R. R. Sgarro
Manager-Nuclear Regulatory Affairs

BELL BEND NUCLEAR POWER PLANT
RESPONSE TO RAI SET No. 33
BNP-2009-251 Docket No. 52-039

Response to NRC Request for Additional Information Set No. 33,
Questions 08.03.01-1 and 08.03.01-2
Bell Bend Nuclear Power Plant

Figure 8.3-1 {BBNPP Emergency Power Supply System Single Line Drawing}

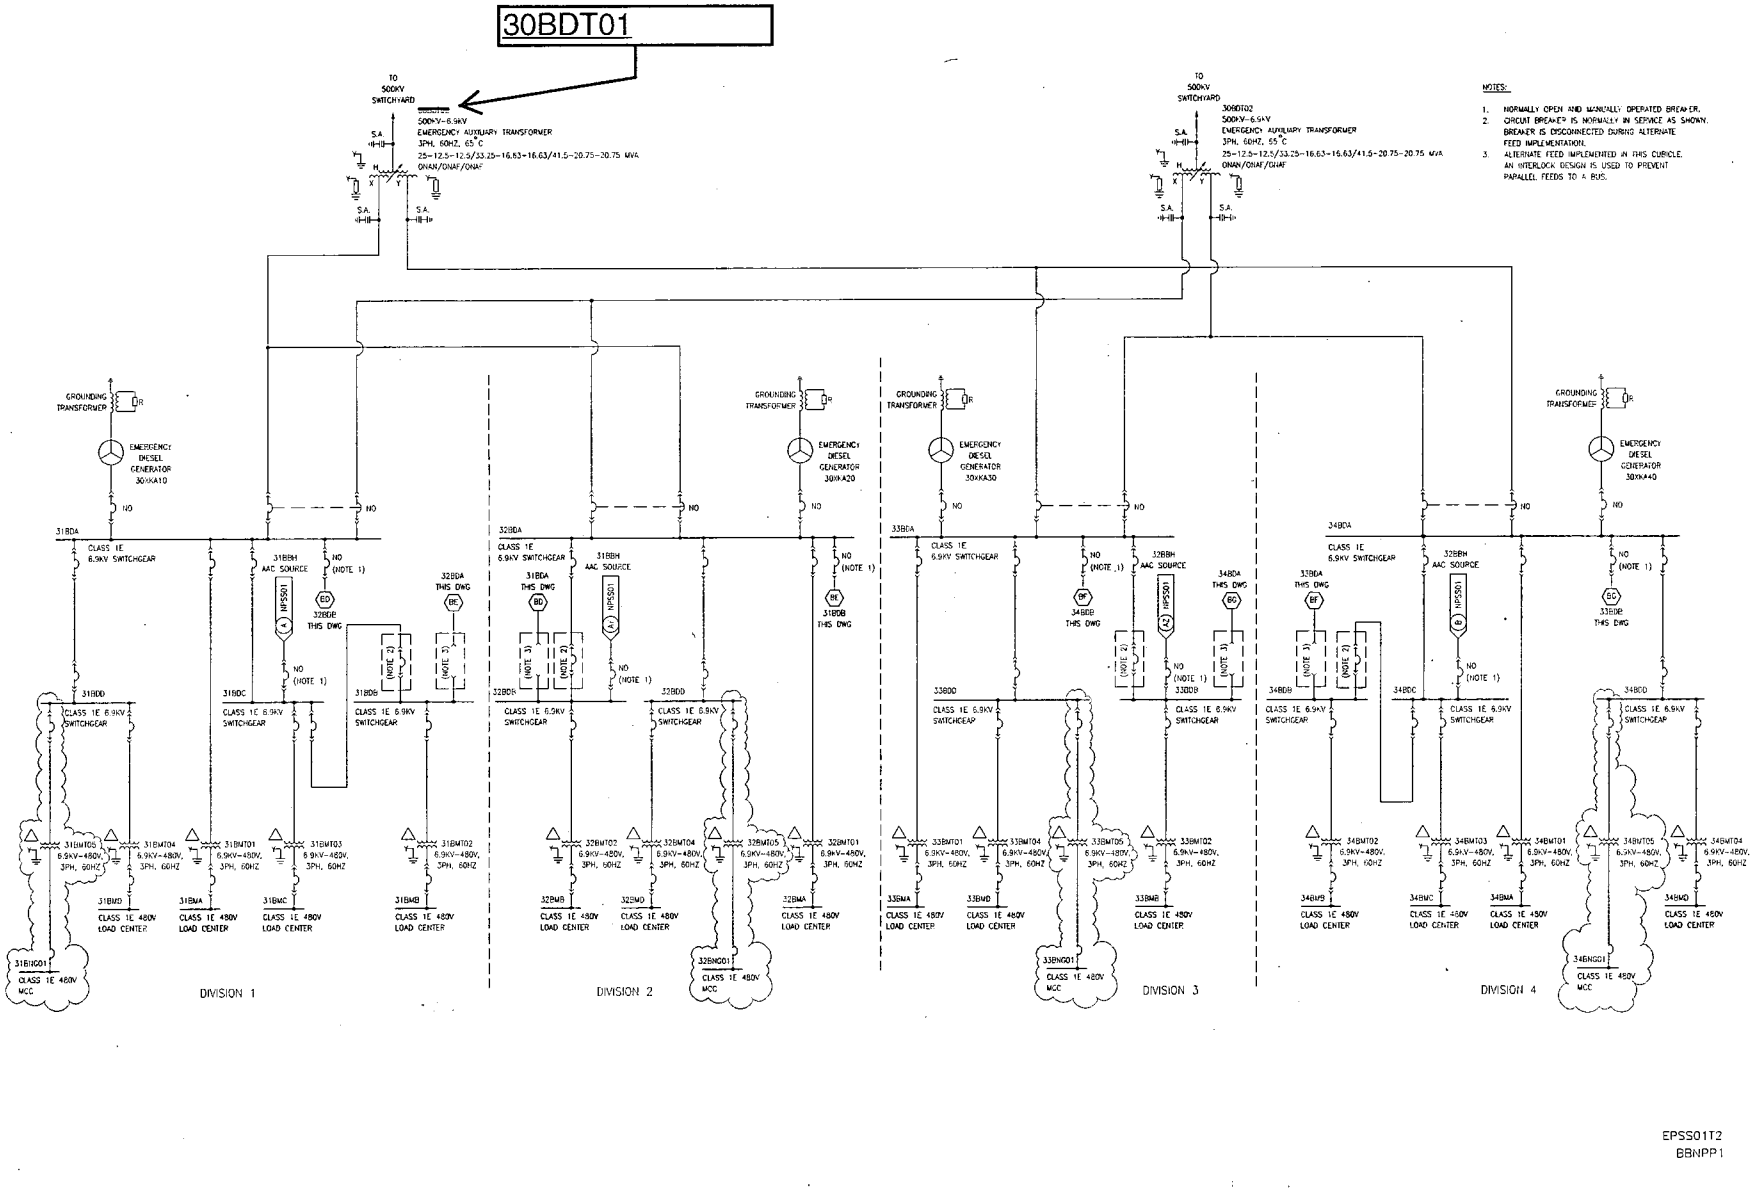
FSAR Figure 8.3-1, Emergency Power Supply System (EPSS) Single Line Diagram, appears to contain a typographical error. Clarify whether this figure shows two 30 BDT02 transformers (EATs), as labeled, or whether it should label one as 30BDT01 and the other as 30BDT02.

One transformer in FSAR Figure 8.3-1, Emergency Power Supply System (EPSS) single line diagram was labeled incorrectly. The transformer numbers are 30BDT01 and 30BDT02. The transformer labels in Figure 8.3-1 will be corrected.

Figure 8.3-1, Emergency Power Supply System (EPSS) single line diagram will be updated in a future revision to the COLA, as indicated.
